Safety Review of Proposed Intersection of 'Spine Road' and Hurontario Street

Schedule 'C' Class Environmental Assessment for Widening of
McLaughlin Road and Construction of East-West Spine Road
(Mayfield West Phase 2)

TPB166090

Town of Caledon

HWY 410 INTERCHANGE
CLASS ENVIRONMENTAL ASSESSMENT
 TOWN OF CALEDON
FIGURE B-3 WESTBOUND RIGHT
DEPARTURE SIGHT DISTANCE

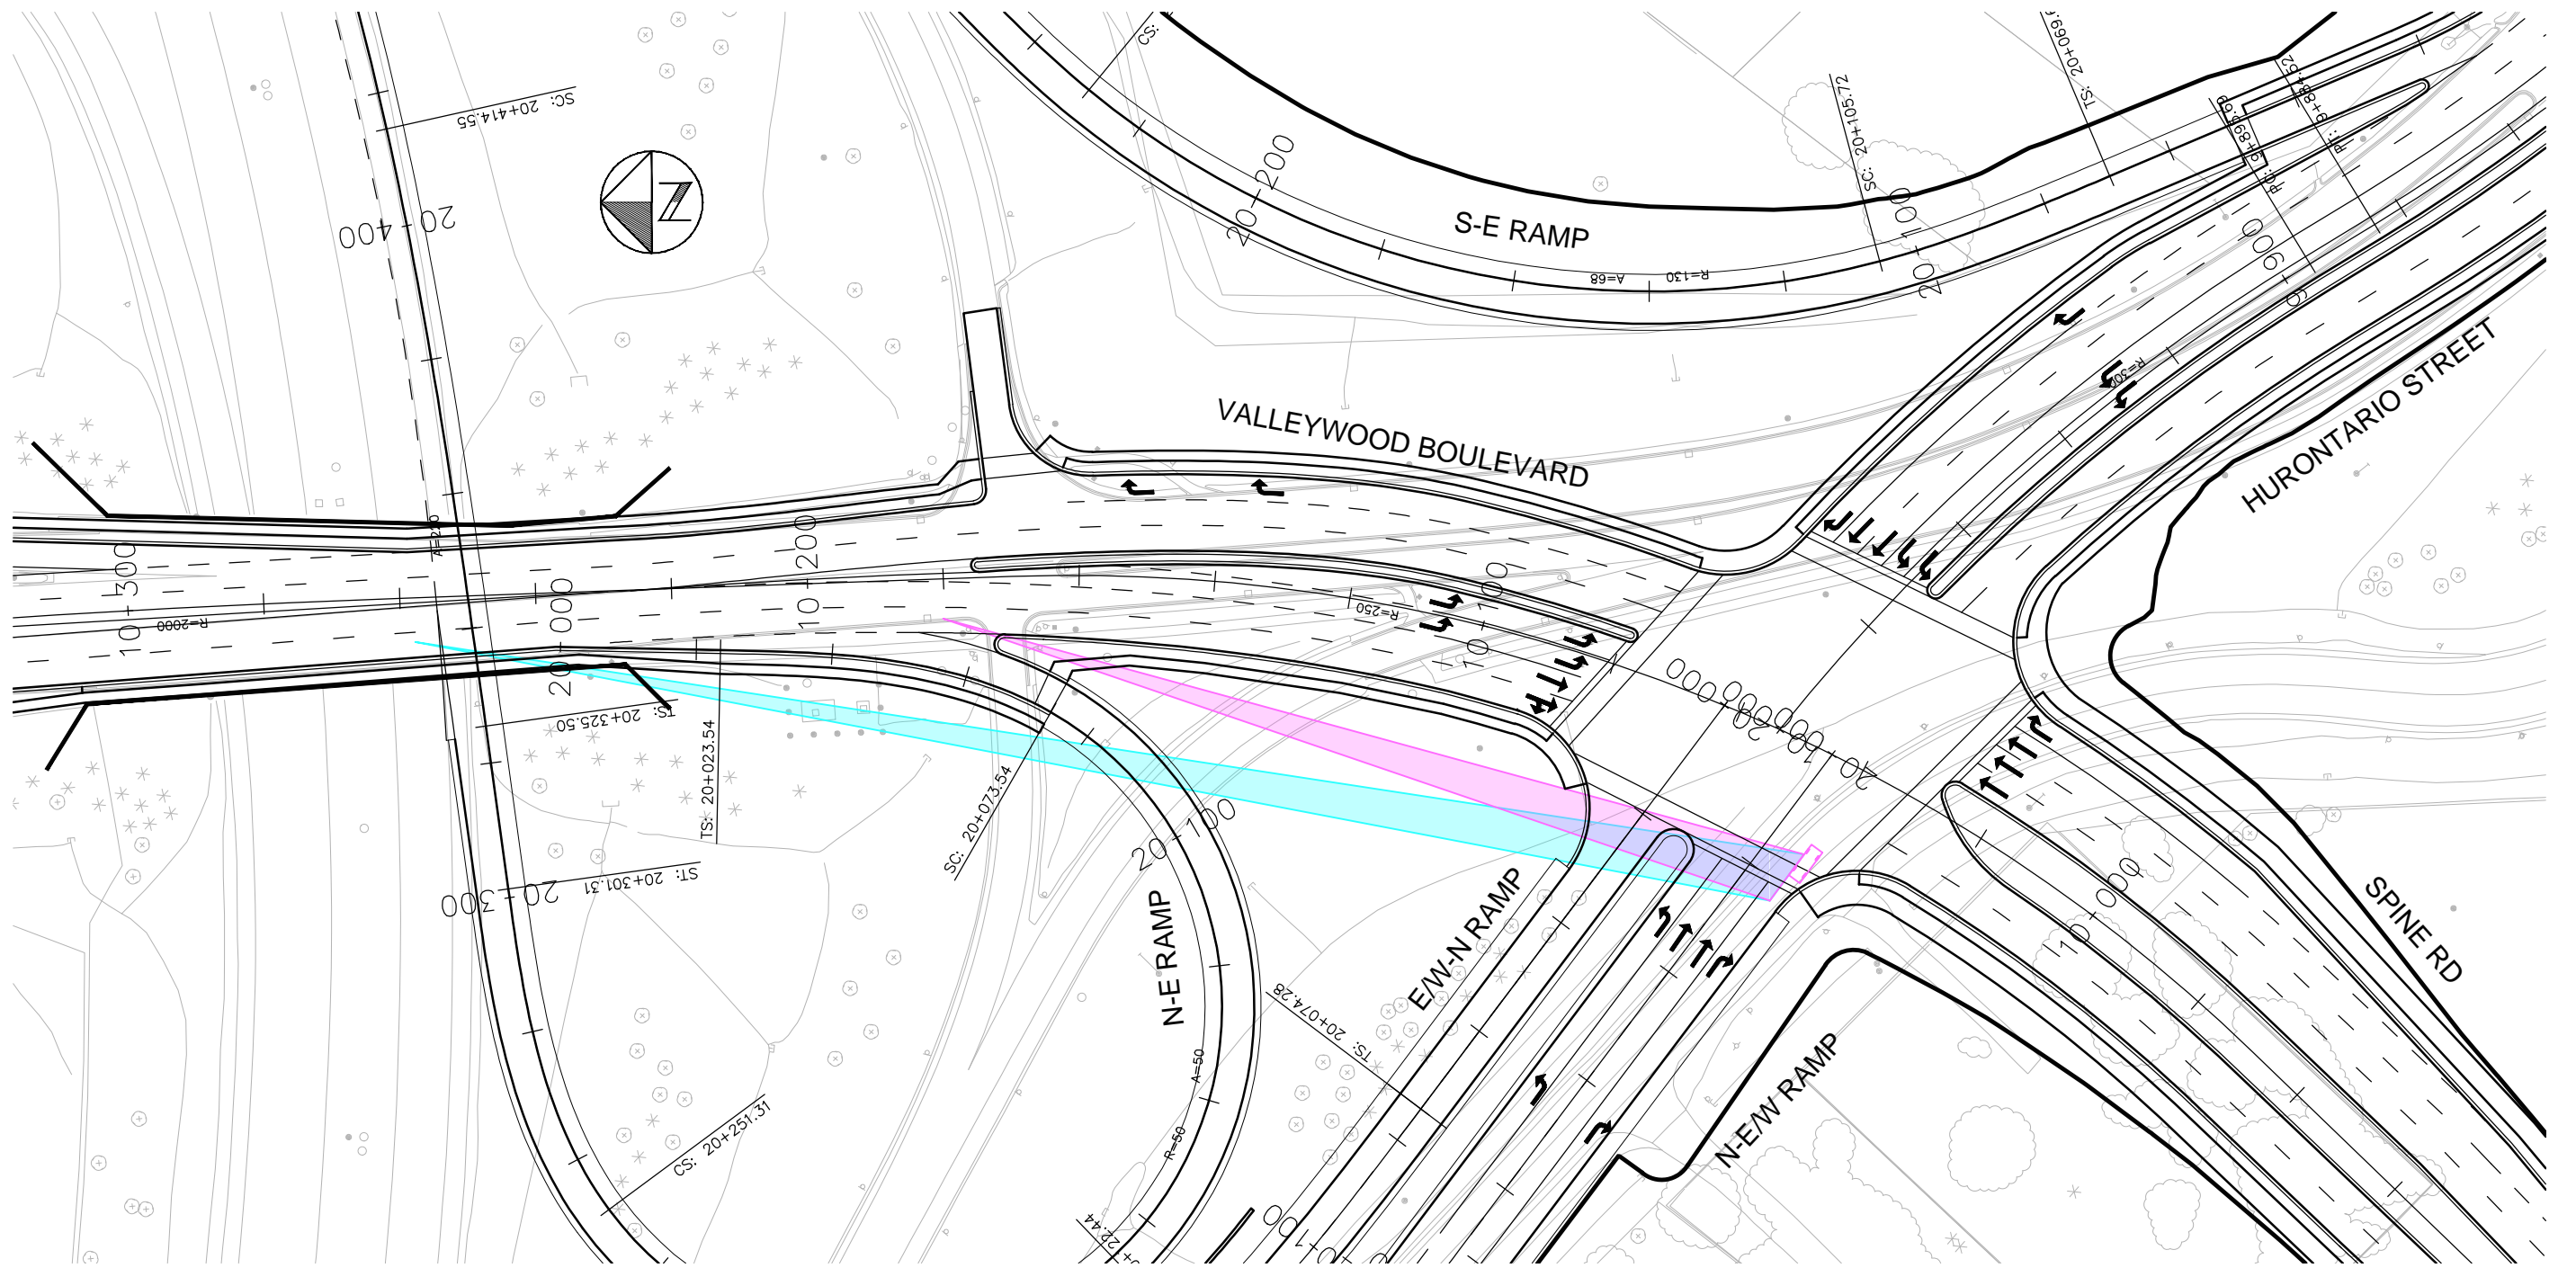
Right turn departure sight distances were checked for both passenger vehicles and WB20s (design vehicle) – refer to Table 6 . While the sight distances for passenger vehicles are acceptable, the horizontal departure sight distances for the WB20 are not. The departure sight distance triangle for the WB20 extends from Station 10+040 (truck location) to Station 10+258 (decision sight distance), with views impeded by both the N-E Ramp to Highway 410 and the railings of the overpass structure. Diagrams illustrating the departure sight distance triangles for the subject movement are provided as Figure B-4 in **Appendix B**.

Additional consideration for movements made from the inside of a curve include the "over the shoulder" angle of visibility (ϕ , Φ). 2Φ is approximately equivalent to the angle formed between the mid-line of the departing vehicle and the mid-line of the vehicle approaching from the left (at the departure sight distance). While not explicitly identified within the TAC Geometric Design Guide for Canadian Roads (2017), acceptable ϕ , Φ angles are identified within TAC's Canadian Roundabout Design Guide (2017). Per Section 6.3.11 of the TAC Roundabout Guide, acceptable angles range from $2\Phi = 40$ degrees to $2\Phi = 120$ degrees, with the lower end of the range causing issue due to straining and/or requirement to use mirrors to check for vehicles. On the southbound approach, the angle between the natural travel path of the right-turning vehicle and a vehicle at the extent of the departure sight distance is $2\Phi = 67$ degrees

for passenger vehicles, and $2\Phi = 61$ degrees for WB20s. While both values are within the acceptable range, they are towards the lower end, with additional strain introduced by the adjacent vertical curve.

Design Vehicle	Driver's Eye Height (m)		Departure Sight Distance and Station	Vertical Sight Distance Acceptable		Departure Sight Distance Acceptable
	TAC	MTO		TAC	MTO	
Passenger	1.08 m	1.08 m	130 m (~STA 10+180)	Yes	Yes	Yes
WB20	2.40 m ²	2.33 m	205 m (~STA 10+258)	Yes	Yes	No

Strategy		Potential Impacts and Limitations	Anticipated Effectiveness
1	Provide right turn receiving lane on westbound Spine Road.	While eliminating direct conflicts with through right-turning vehicles, visibility for merging out of the receiving lane would be significantly limited given the anticipated downgrade operating speeds and the minimum radius curve on Spine Road.	Low
2	Introduce 'Right on Red' restrictions.	If adhered to, would eliminate collision risks.	Moderate
3	Relocate intersection further west to move limit of departure sight distance southwest of interference with the bridge and ramp.	Would eliminate visual conflict with bridge and ramp. Would require additional property from private landowners.	High
